ADDENDUM #2

PROJECT: Firebaugh Center Surveillance Cameras REBID

[Changes to the Project Scope, Scope of Work \(highlighted additions or adjustments\):](#)

Camera RFQ Plans – Addendum 2.pdf

TECHNOLOGY LEVEL 1 OVERALL REFLECTED CEILING PLAN

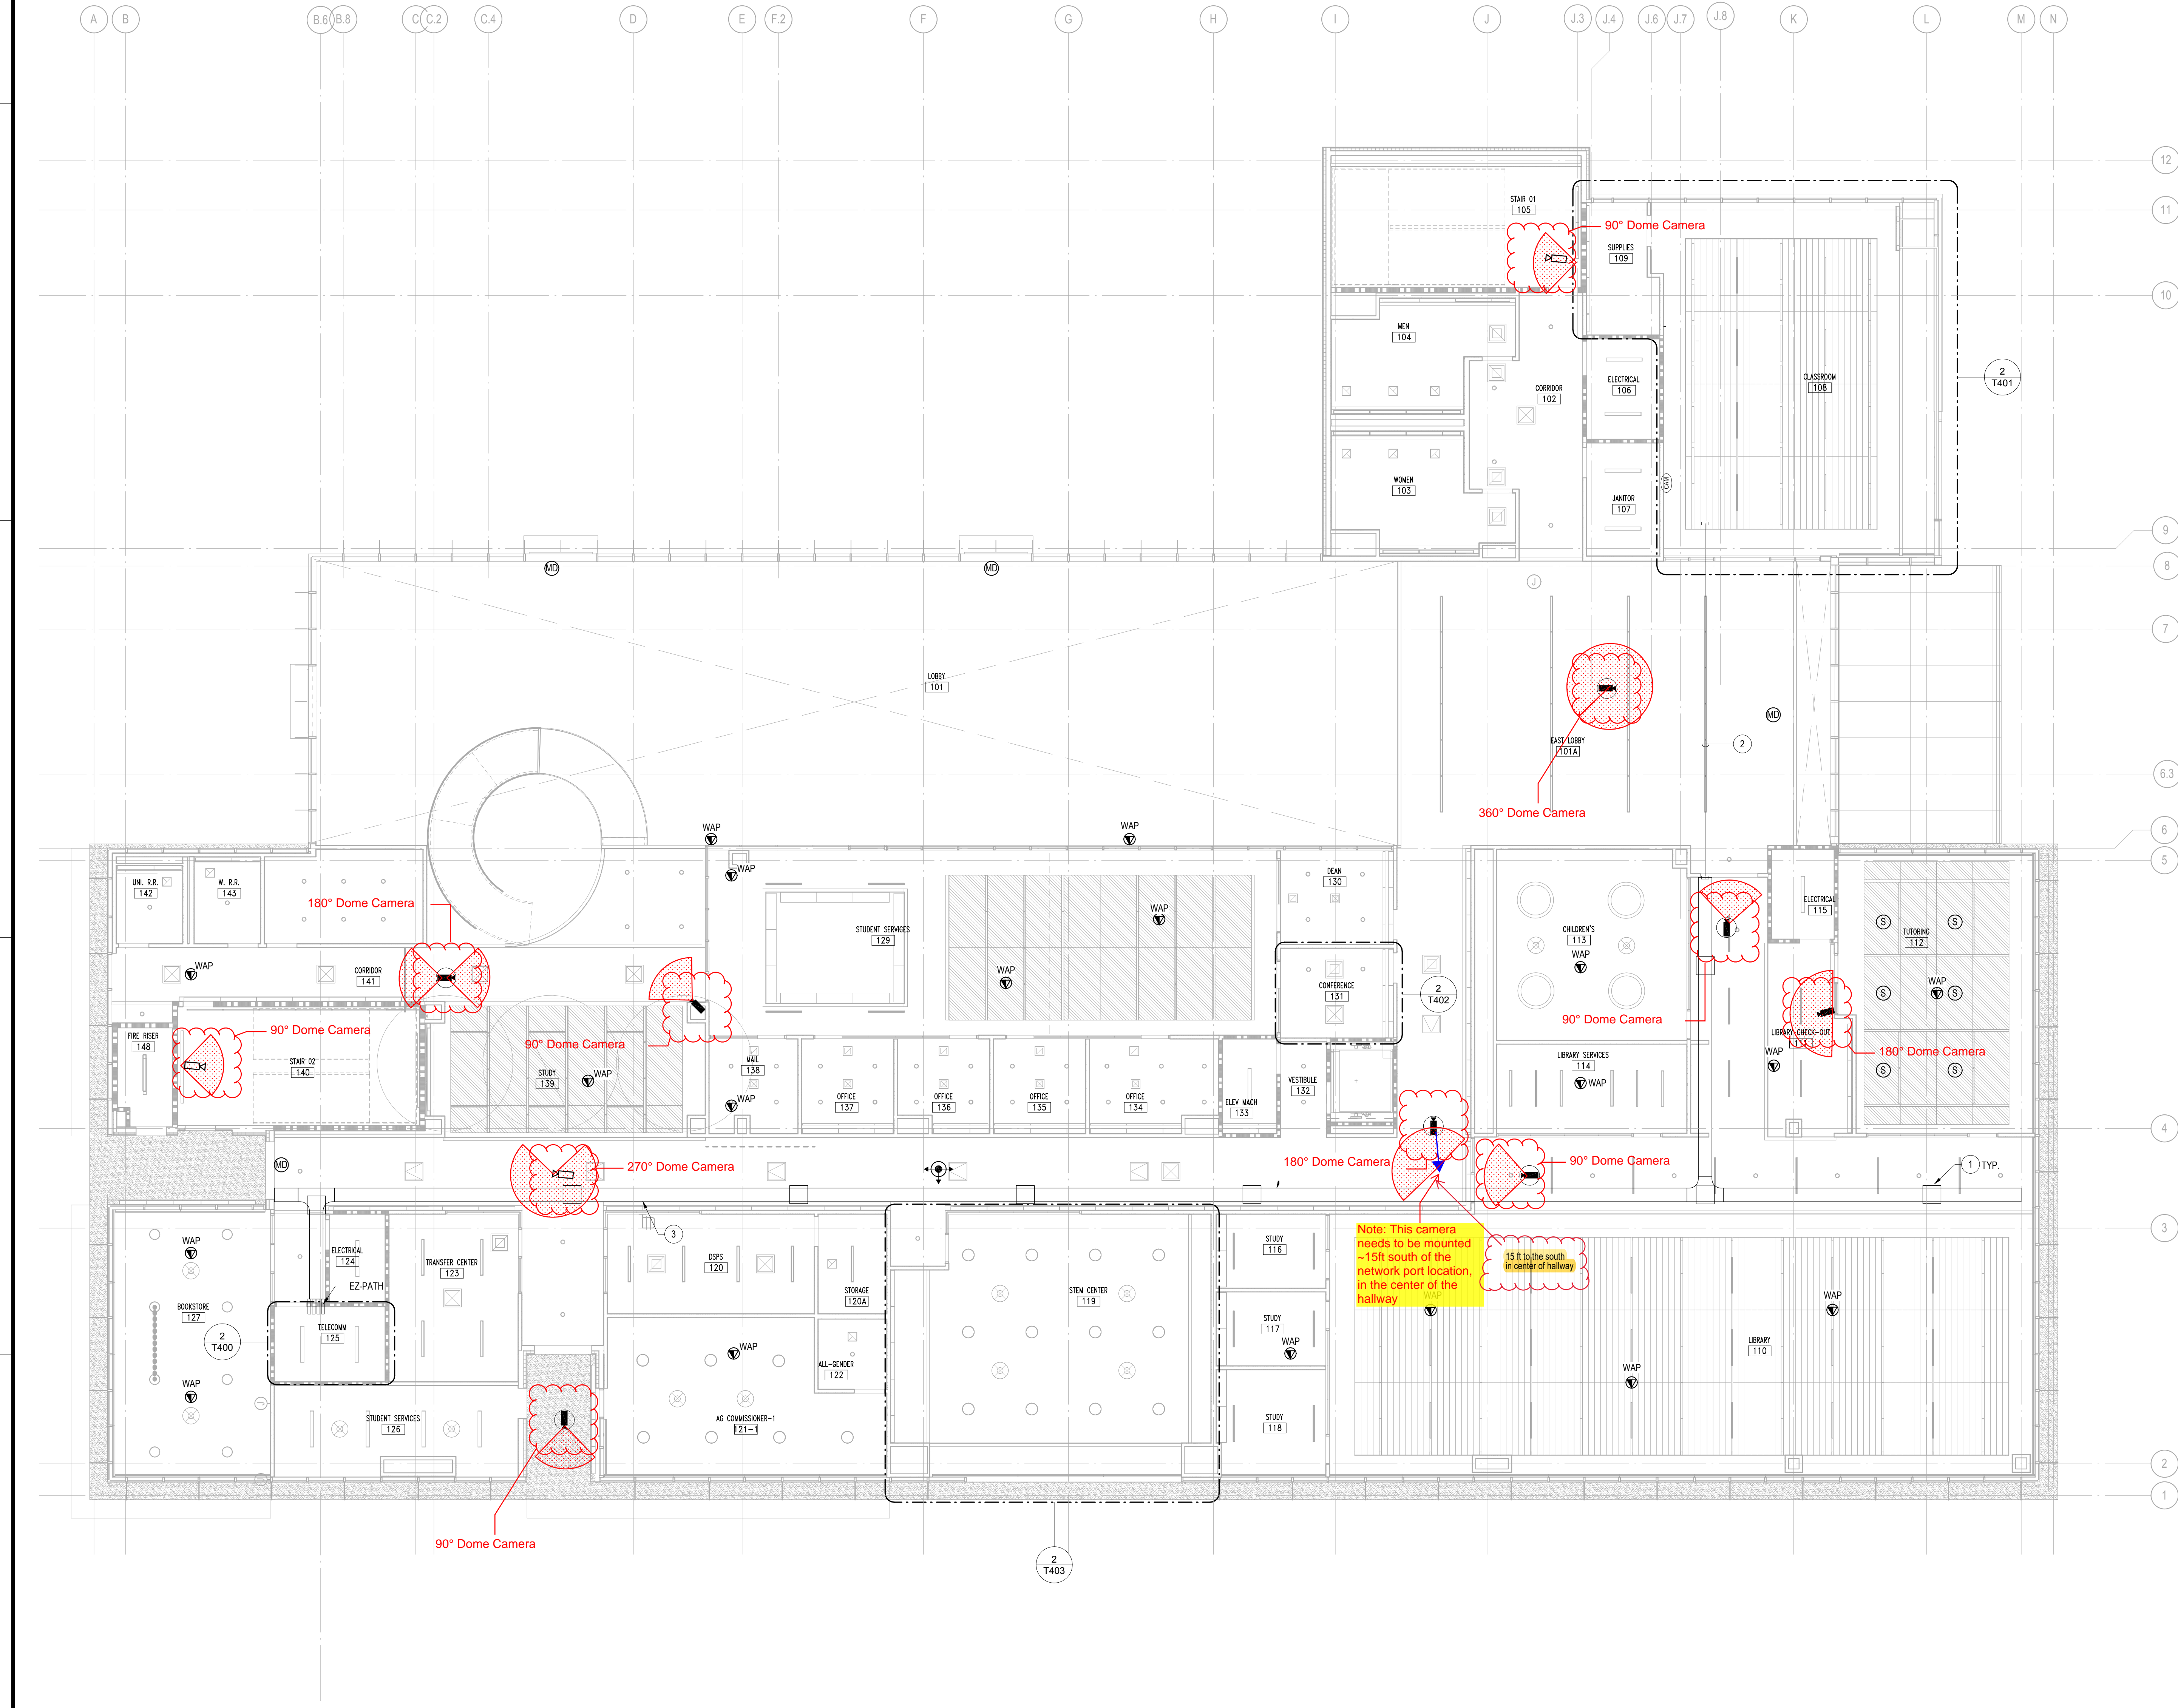
- The 180-degree dome camera in the SE corner adjacent to vestibule 132 in the first-floor hallway will need to be mounted approximately 15ft away from the network jack location to the center of the hallway to obtain the indicated view. This cabling extension will need to be pulled above the ceiling in the crawl space (not surface-mounted).

TECHNOLOGY LEVEL 2
 OVERALL REFLECTED
 CEILING PLAN

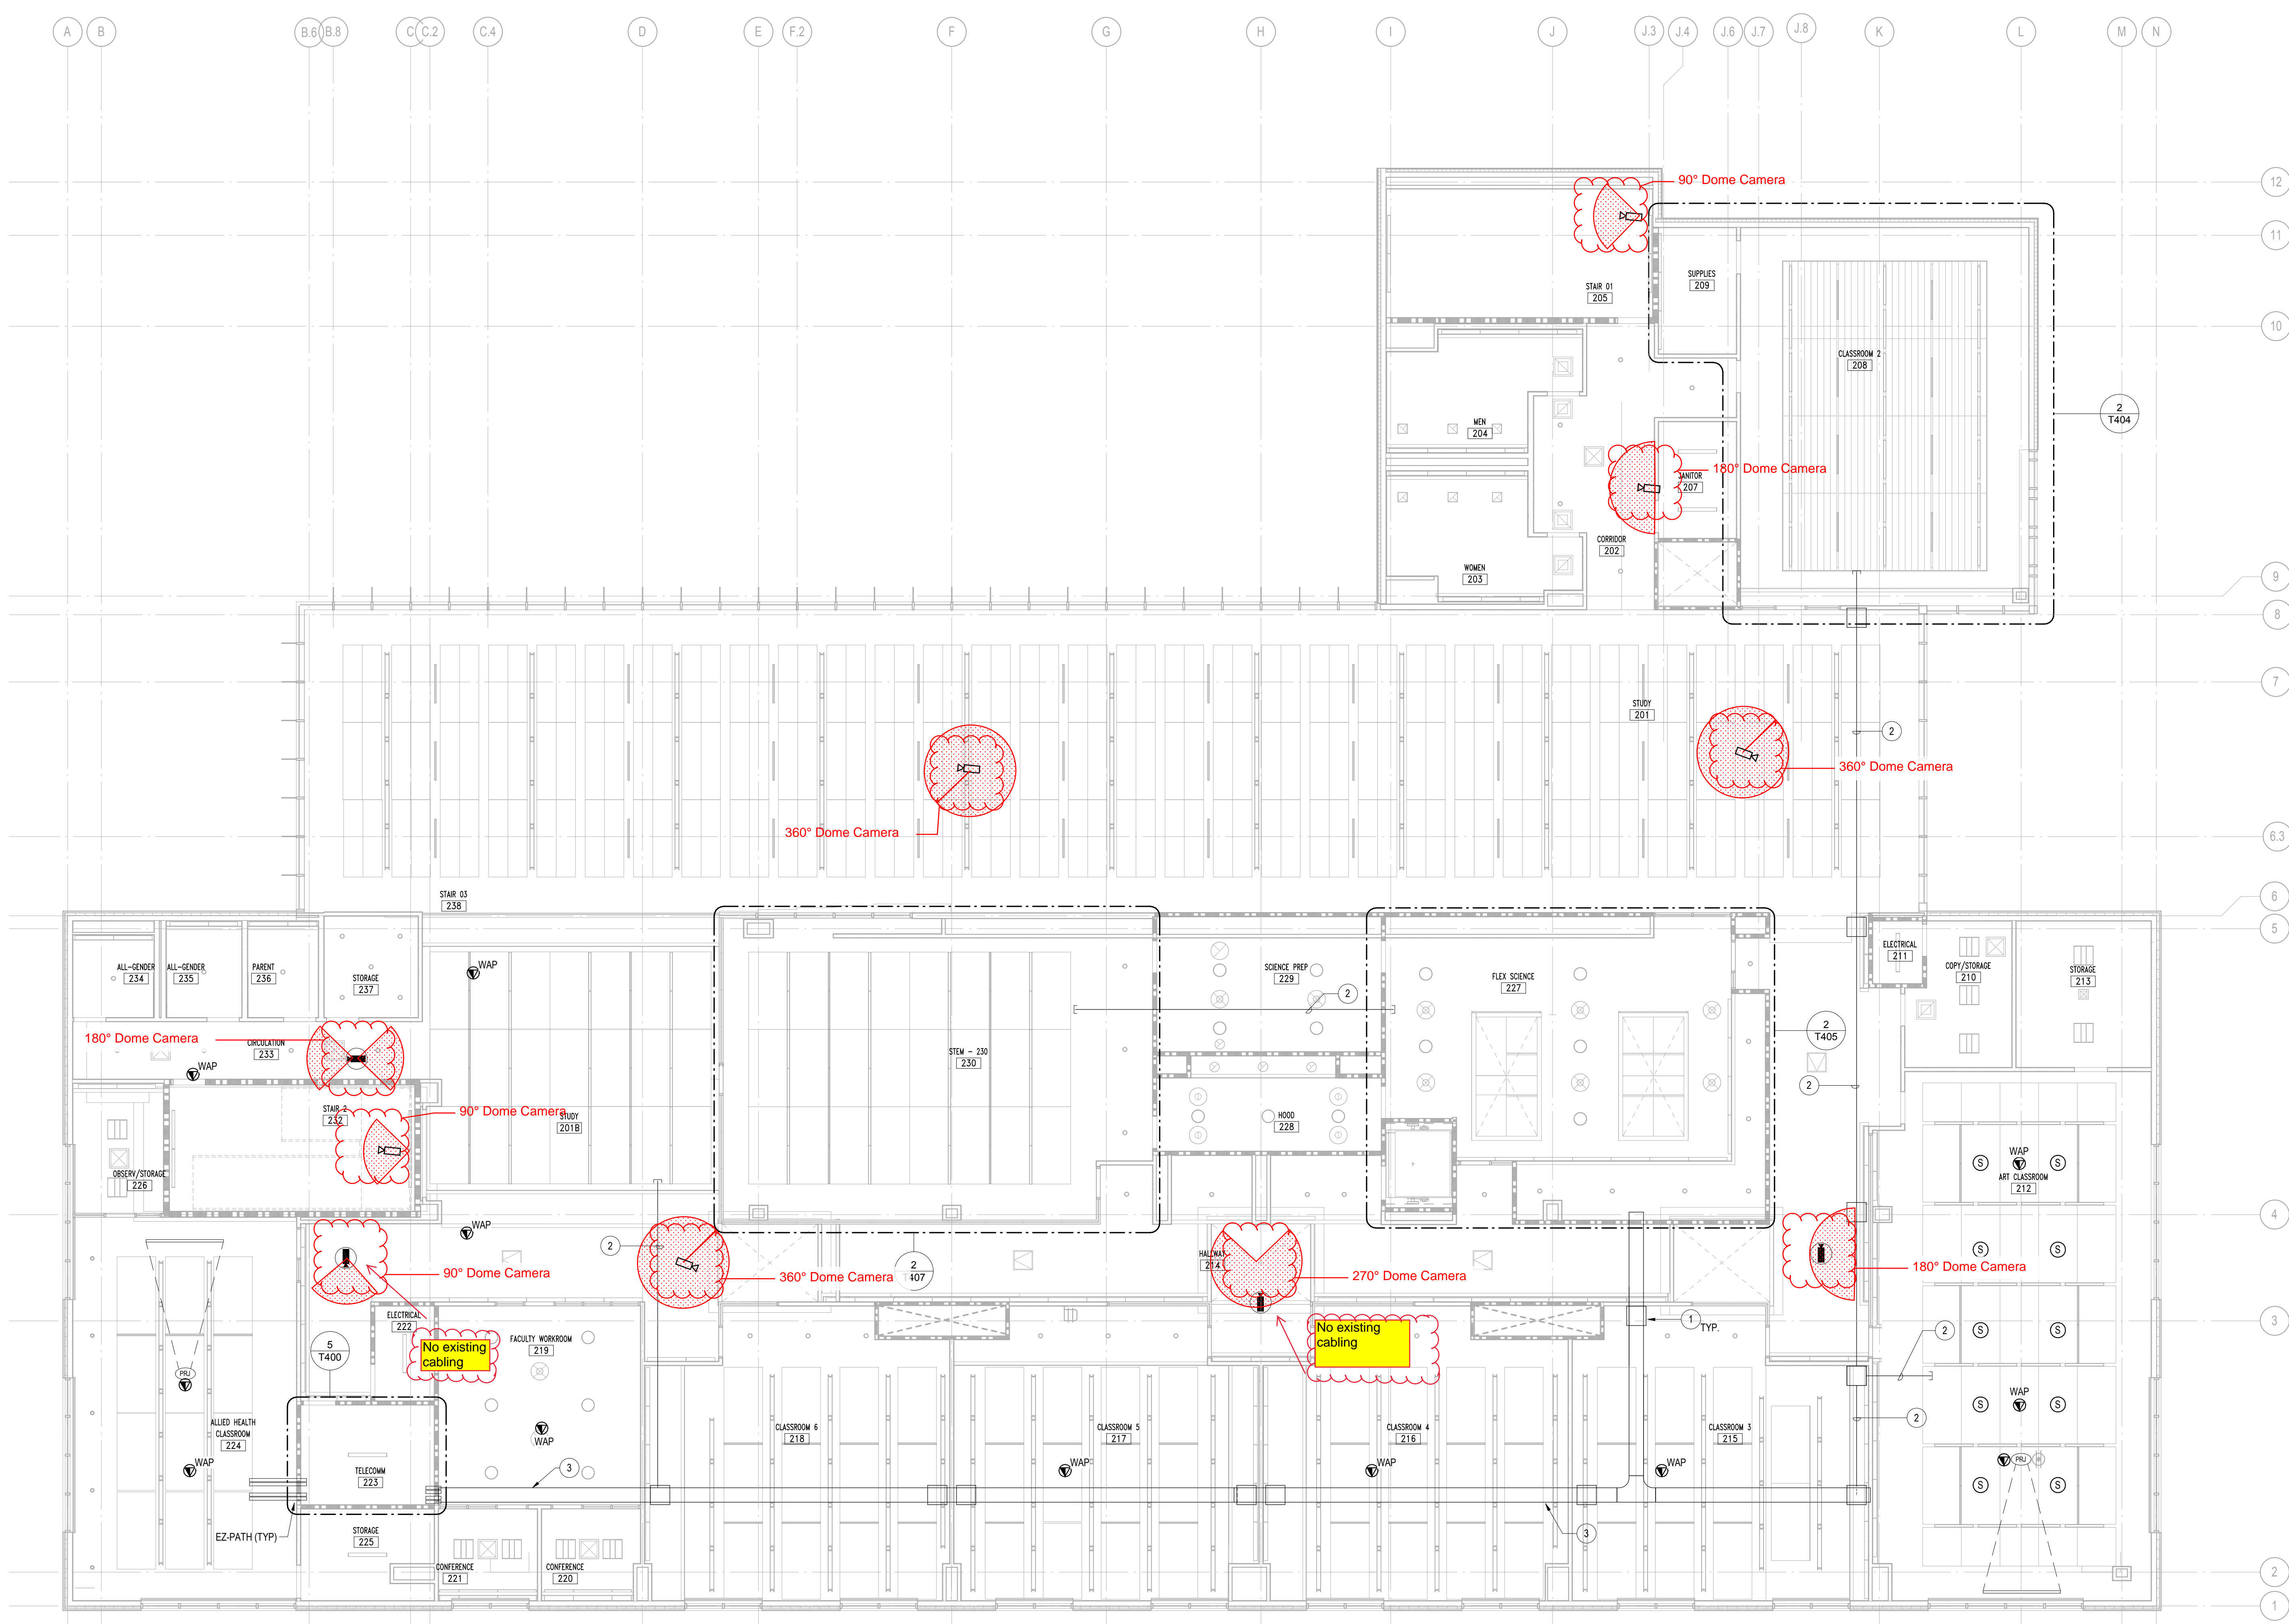
- Conduit pathway exists for all exterior locations, which are to be mounted on existing light poles.
 - Floor 1: 3 camera needs networking added
 - Floor 2: 8 cameras need networking added
 - Outdoor: 6 cameras need networking added
 - All other cameras have networking in place.
